4	INC. DCN ISID2-007B-5 PER DCR 00-1766	SBW		
5	INC. DCN ISID2-007B-4 PER DCR 04-0010 & GEN. UPDATE REMOVE SHT. 1 (DOUBLE CALL-OUT) AT ZONE C-3 PER ENGR COMMENT AND ISIM REVIEW		INITIALS ON FILE	
6	INC. DCN ISID2-007B-3 FOR RFA 94-0452		INITIALS ON FILE	
7	INC. DCN'S ISID2-007B-1 & 2 FOR DCR 91-0011		INITIALS ON FILE	
8	ISSUED FOR SECOND 10 YEAR ISI PROGRAM	JJK	TRN	TWB
9		BY	CHK'D	ENGR.
10		DATE	DATE	DATE
11		DESIGNED	DRWN	CB
DAVIS-BESSE NUCLEAR POWER STATION UNIT NO.1				
INSERVICE INSPECTION DIAGRAM STEAM GENERATOR SECONDARY SYSTEM				
ISID2-007B				
4

D-122

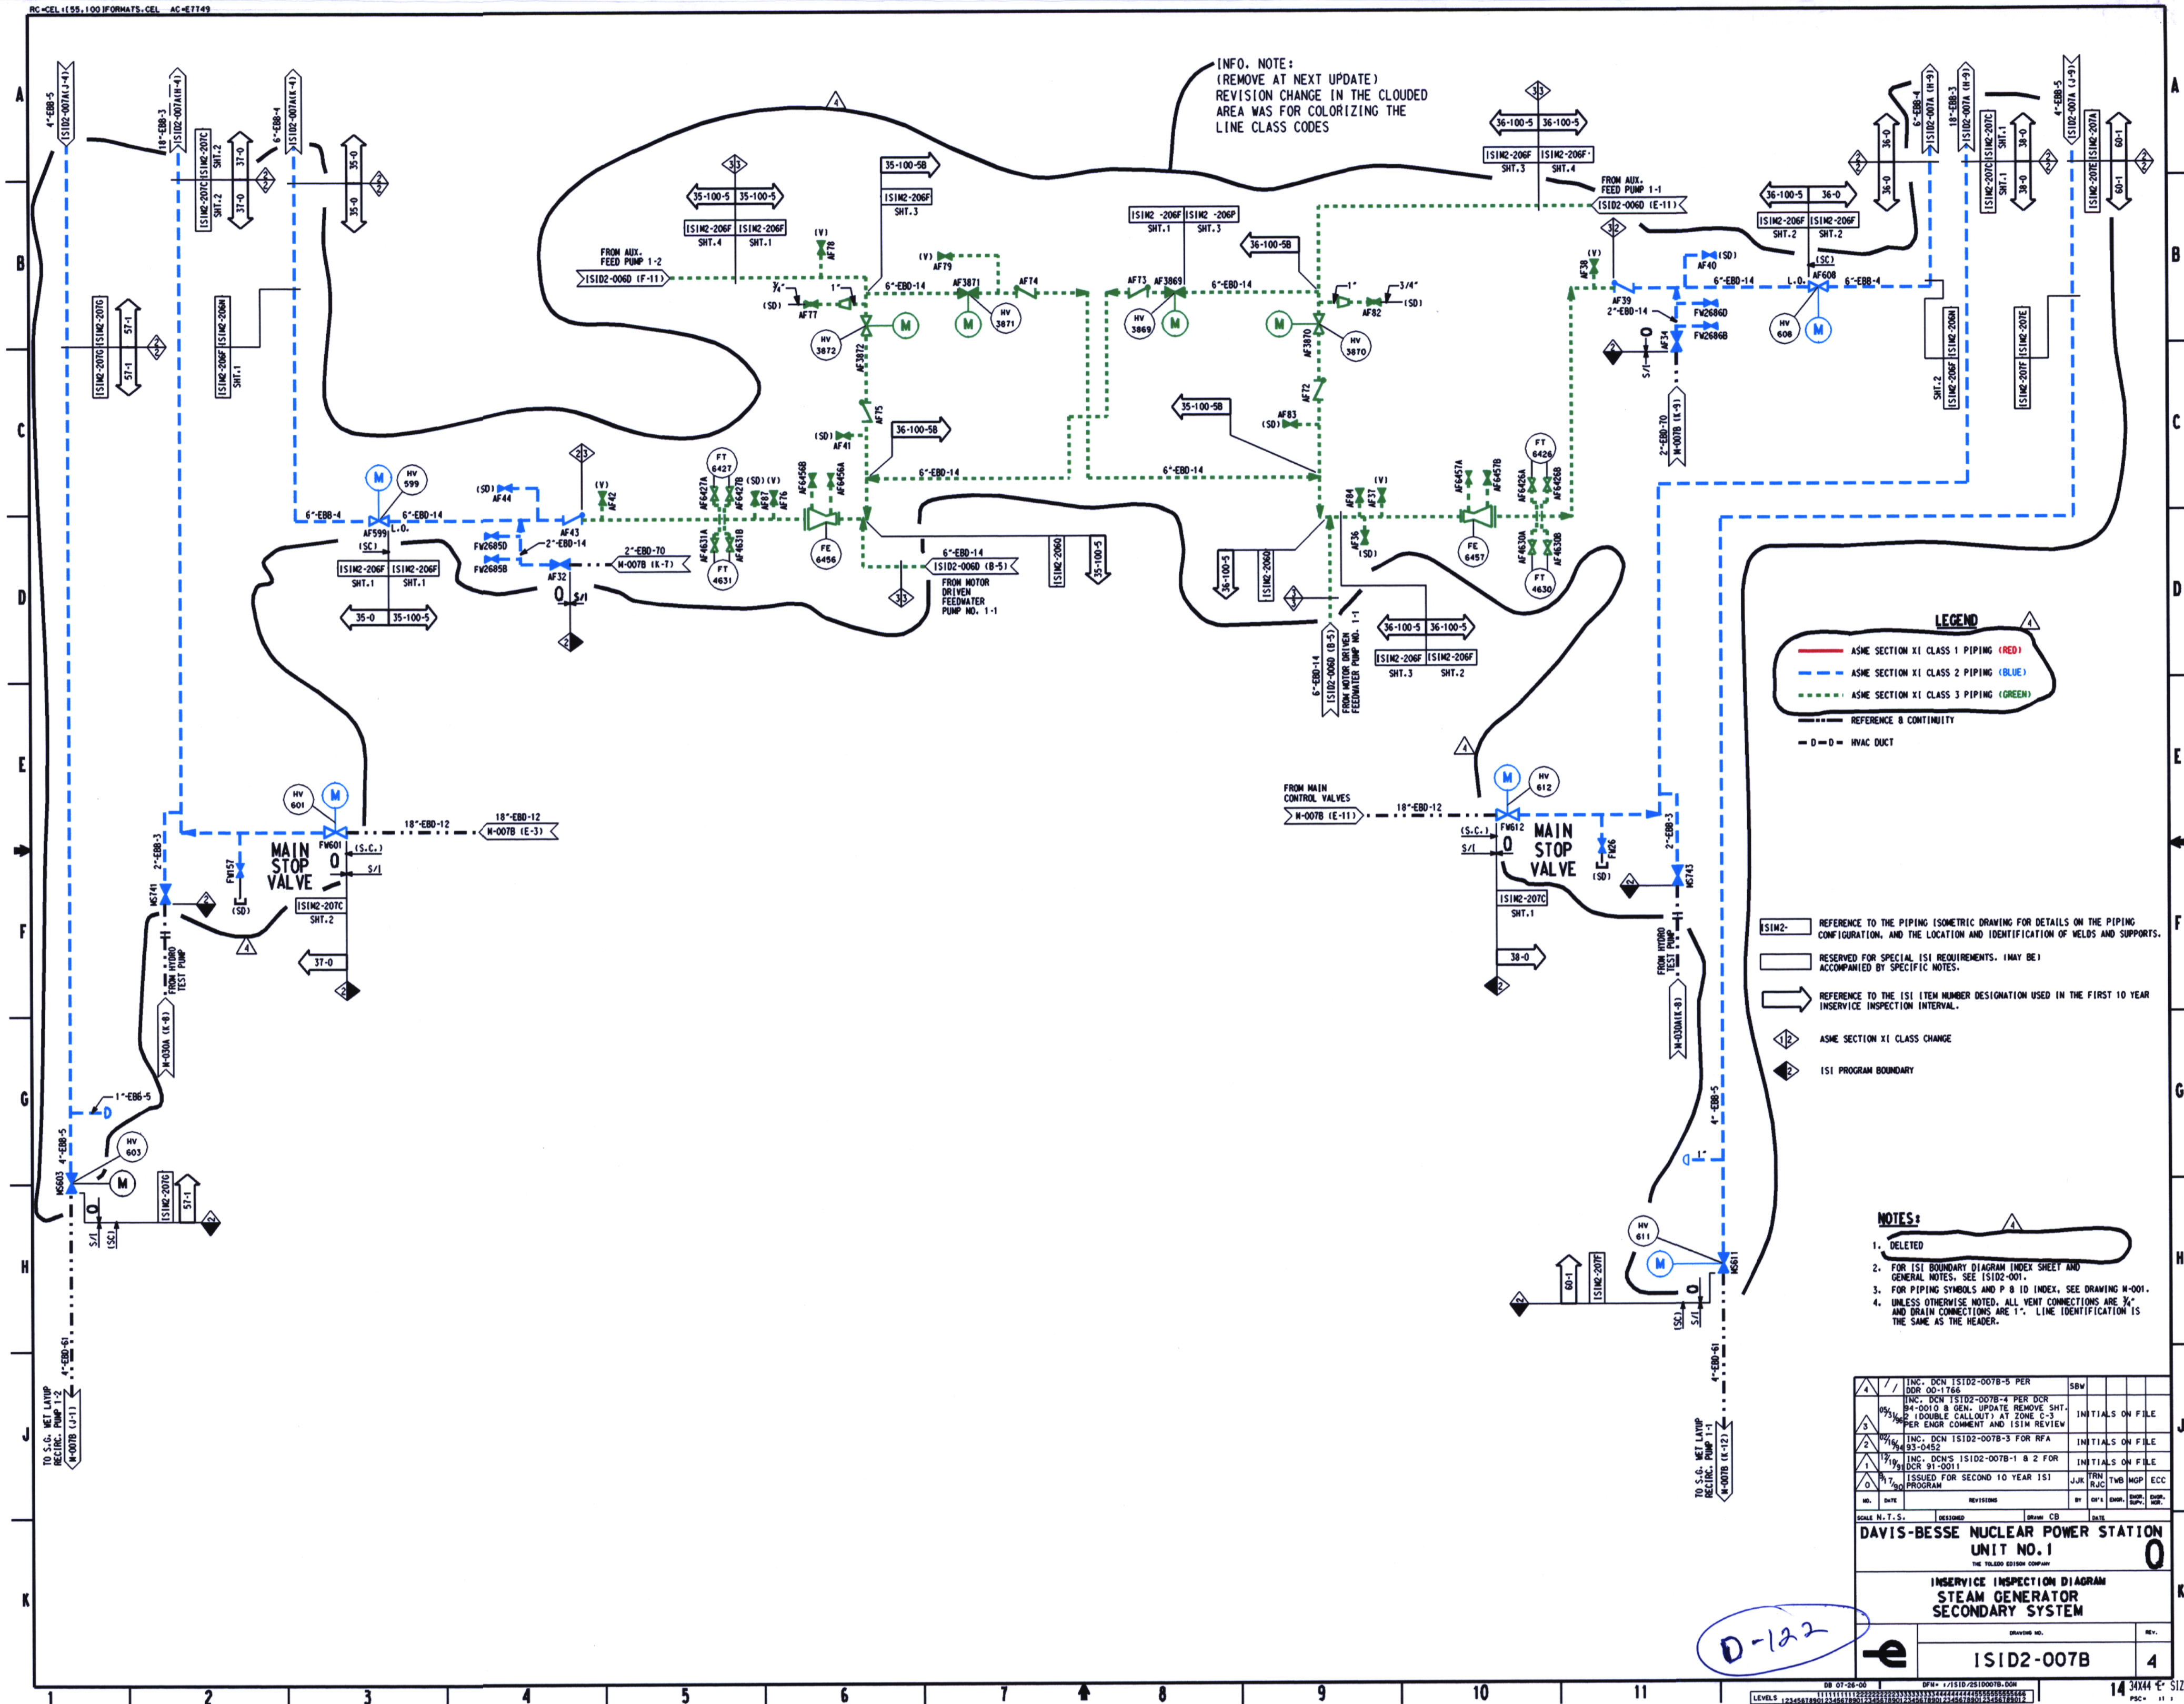
INFO. NOTE:
(REMOVE AT NEXT UPDATE)
REVISION CHANGE IN THE CLOUDED
AREA WAS FOR COLORIZING THE
LINE CLASS CODES
